Product hierarchy no. *				Part no.	SBU	Product Type	Customer part no.
SBU	PG	PUG	Type				
02	007	050	0000002081	See list below	Connectors	Cord retaining kit

Product Change Notification					PCN Cord retaining kit - Change of material		
owner	creation date	release date	released by	change order	rev	page	D10-091-862
huberth	02.07.2025	02.07.2025	gassmael		B	1 of 1

Current nuts	New nuts

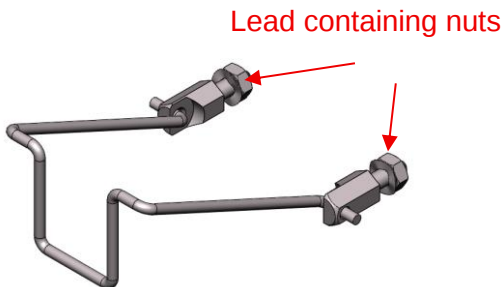
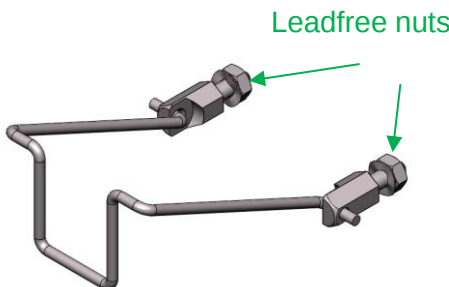
- Change of material

- Change of nuts from brass nickel plated to leadfree steel zinc plated

The change takes effect in ww 26/2025 (Date code 2526 or higher on label).
Parts on stock will be used upon depletion.
